14 December 2012  
File No. 38706-119

**Re: Response to Request for Information dated November 8, 2012  
Class III Underground Injection Control (UIC) Well Permit Application  
Curis Resources (Arizona) Inc.**

FIGURE 11-2

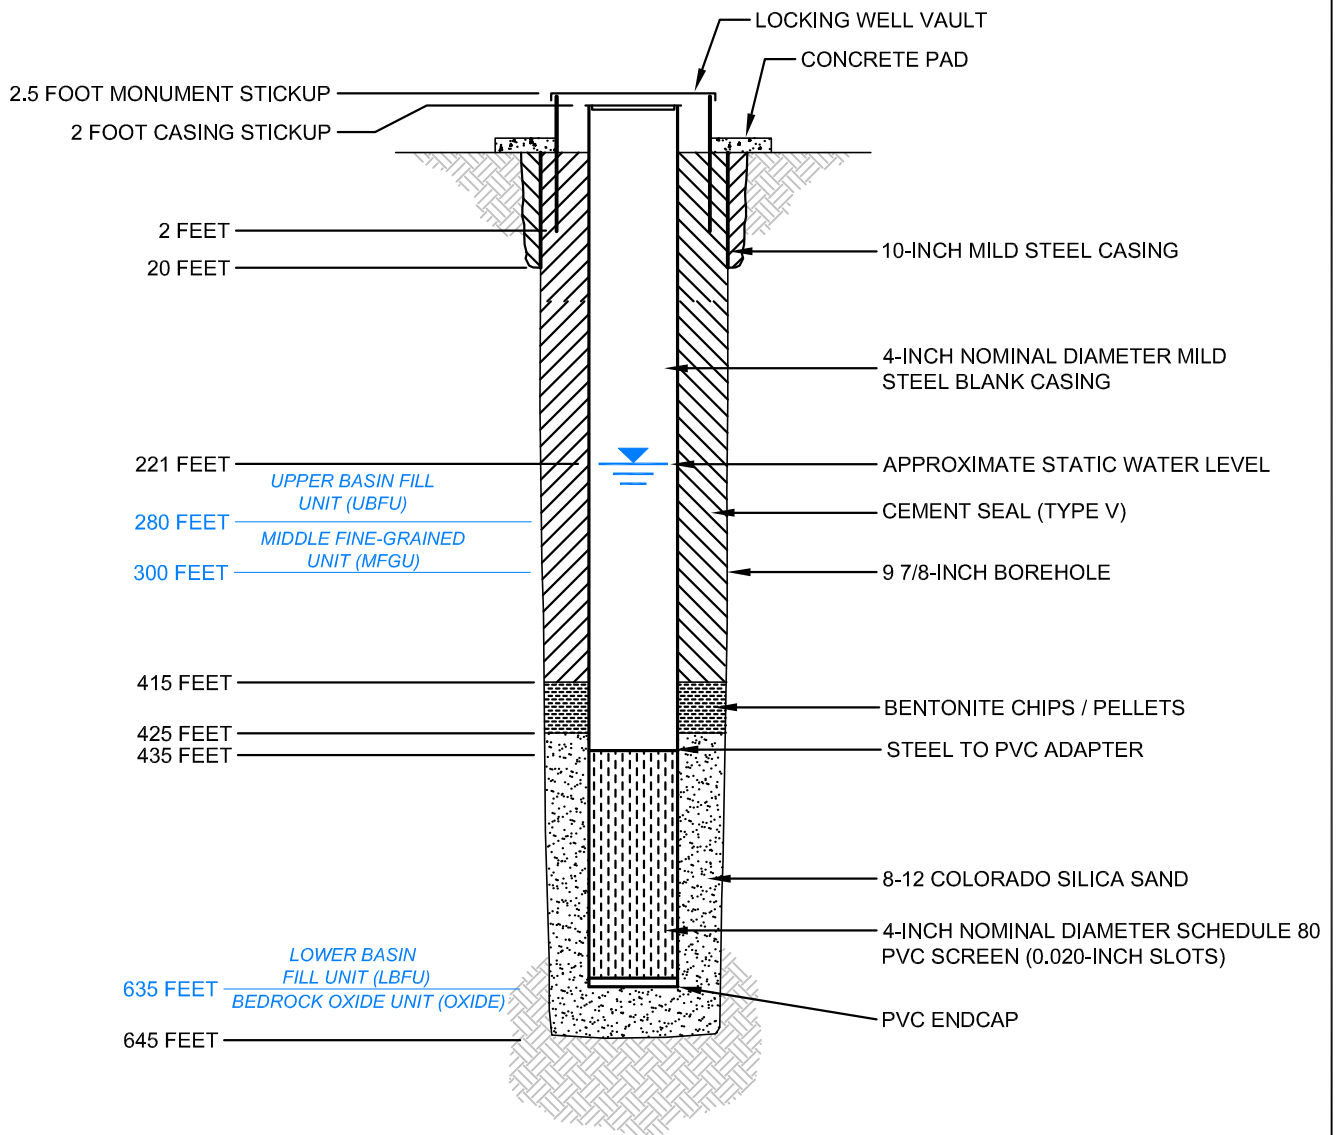
*11. Demonstration of Hydraulic Control: Please provide a proposed plan for an additional monitoring well in the lower 200 feet of the LBFU to the east of the PTF and above the area where Sidewinder fault and other faults meet the Oxide-LBFU contact. The recommended location is approximately 300 feet east of the outer recovery wells on the eastern perimeter of*

Curis Arizona herein proposes to install a supplemental monitor well (M61-LBF) located approximately 350 feet east of the PTF Well Field. The proposed location of M61-LBF is shown on Figure 11-1 (Attachment 4). Based on the SRK Geologic model, the LBFU is at its maximum thickness of 335 feet at this location, extending to 635 feet below ground surface. The aquifer exemption extends 200 feet into the LBFU; the portion of the LBFU that is above the aquifer exemption boundary is required to be protected as a USDW. This proposed well will provide a monitoring point to ensure the protection of the upper LBFU as a USDW. M61-LBF will be screened across the bottom 200 feet of the LBFU; a proposed well design is included as Figure 11-2 (Attachment 4).

FIGURE 12-1

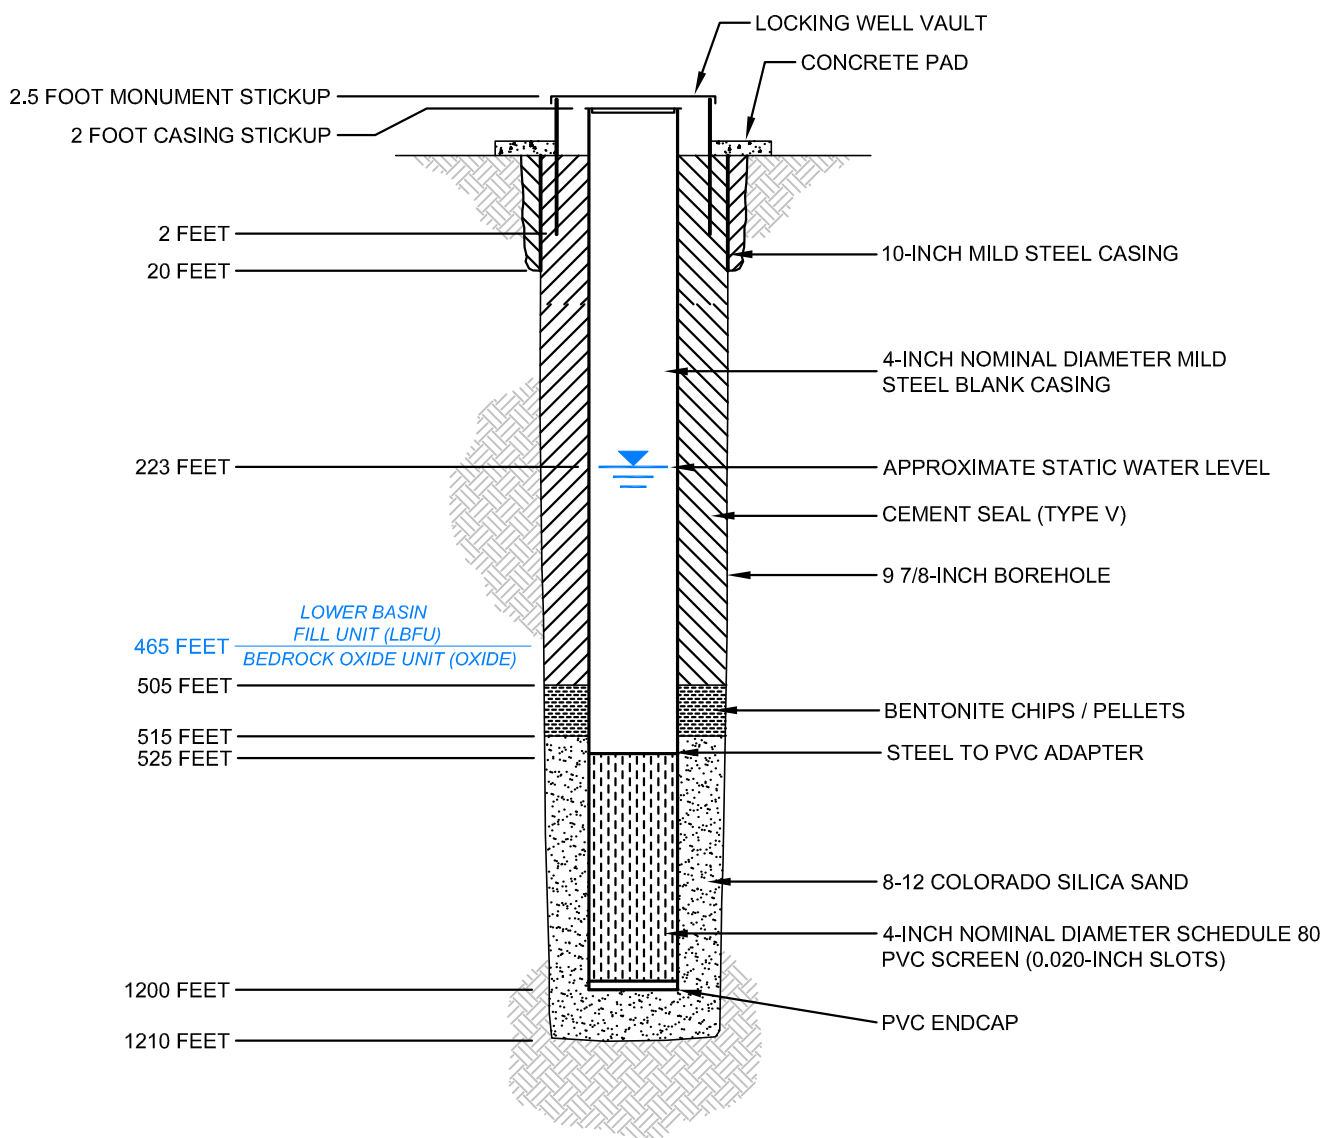
*12. Additional Monitoring in the Oxide Zone: Please provide a proposed plan for additional monitoring wells: one each at the most northern, western, southern, and eastern extent of the 2 mg/L contour in Figure 14A-37, labeled "Extent of Sulfate Migration within the Oxide (All Layers) 5 Years after Closure". All of these wells should be screened in the Oxide injection zone. The northern well would be screened in the Sidewinder Fault Zone where it intersects the Oxide Zone to monitor preferential flow down gradient in the fault zone. Please confirm that coincides with the northernmost extent of the predicted sulfate migration since the Sidewinder Fault Zone is apparently aligned in that position and direction at the Oxide depth in the PTF project area. The southern well would also be placed and screened where the Sidewinder Fault Zone intersects the Oxide Zone. The distance of each well from the well field will vary from approximately 50 feet to 300 feet depending on the position of the 2 mg/L contour relative to the well field. These well locations will serve to assess the accuracy of the predictive simulations for sulfate migration five years after closure and monitor for loss of hydraulic control during PTF leaching operations.*

The proposed wells will be named M57-O, M58-O, M59-O, and M60-O and will be screened from the bottom of the exclusion zone, or from 40 feet below the top of the Oxide zone, to a depth of 1,200 feet below land surface. The northern and southern wells will have screened intervals that intersect the Sidewinder fault plane as inferred in the SRK Geologic Model. Schematic diagrams of the proposed well designs showing the geologic contacts and the fault inferred fault plane intersections for these wells are included as Figures 12-1 through 12-4 (Attachment 5).
